MODEL	REV	CHANGE LIST	Model	CT3/5 MB BOARD	
			Page	FROM	TO
CT3/5 MB 31CT3MB0015 31CT3MB0031	1A	PAGE 2 --- Enable CLK48M from clock generator for the PLL circuit of 7411, and disable the oscillator circuit of PCI7411 PLL. PAGE 3 --- Remove H/W shutdown circuit that supported ADM1032. PAGE 4 --- Use X7R type to replace Y5V type for CPU Decoupling/Bypass capacitor. PAGE 10 --- Add a terminal resistor R706 for -CODE_RST# to improve signal quality. PAGE 11 --- 1. Add a 10K pull-up resistor on MCH_SYNC# for booting. 2. Change the power plane of PCIE_WAKE# from 3VSUS to 3V_S5 to solve system can't turn off issue. 3. Change the power plane of ICH_THRM# and SCI_# from 3VSUS to +3V to reduce leakage. PAGE 12 --- We can also use 5VSUS to instead of 5V_S5 to save cost of MOSFET(A06402). PAGE 15 --- Add a level-shift circuit for EDID interface. PAGE 17 --- 1. Add a off-page and a EMI solution for CLK48M. 2. Remove the reserve resistors (R693-R695) of parallel interface for PCI1510. PAGE 18 --- Remove R696, connect controller and power switch directly . PAGE 19 --- Change R682&R683 value from 56 ohms to 0 ohm cause of BOM error at A-test. PAGE 22 --- 1. Change MC3 type from Y5V to X7R to improv

Size Custom	Document Number	Rev 2A
Date: Monday, December 27, 2004	Sheet 35 of 39

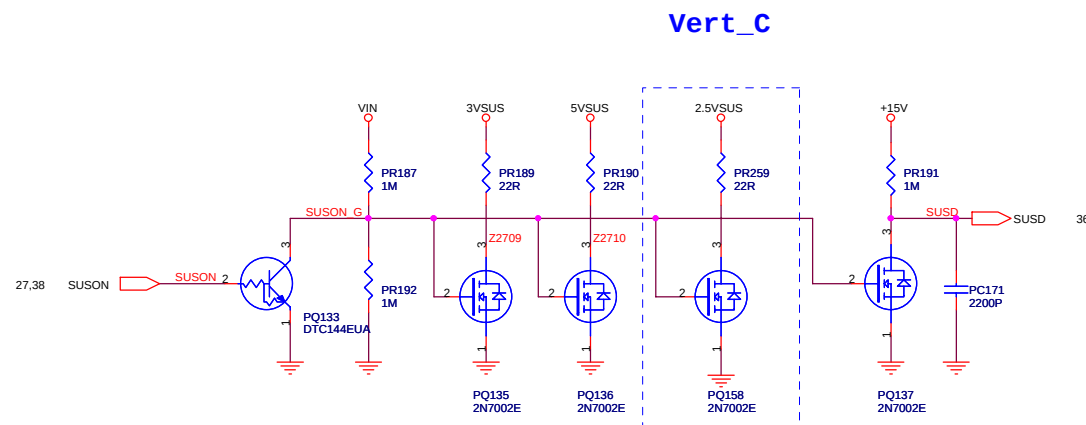
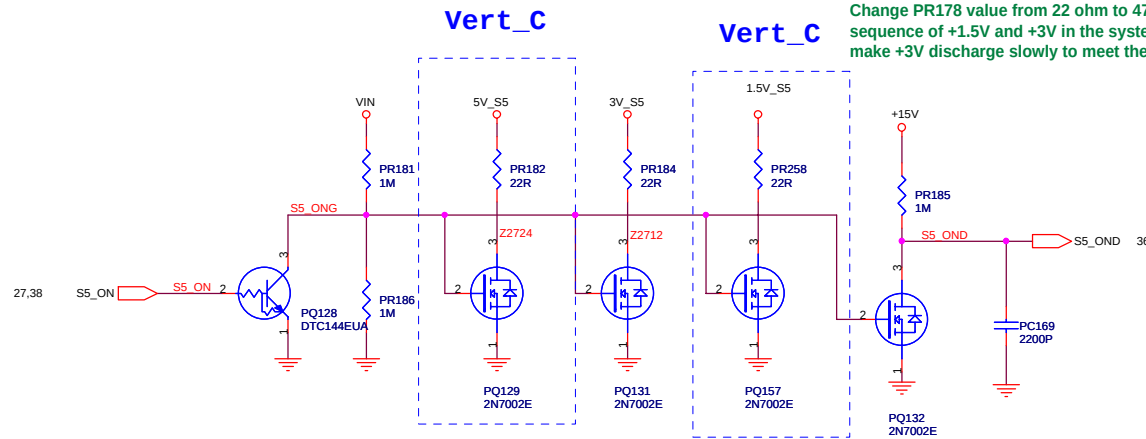
SI stage:
Change PR178 value from 22 ohm to 47 ohm, Intel has required the timing sequence of +1.5V and +3V in the system, we'd like to increase the value to make +3V discharge slowly to meet the specification of falling time.
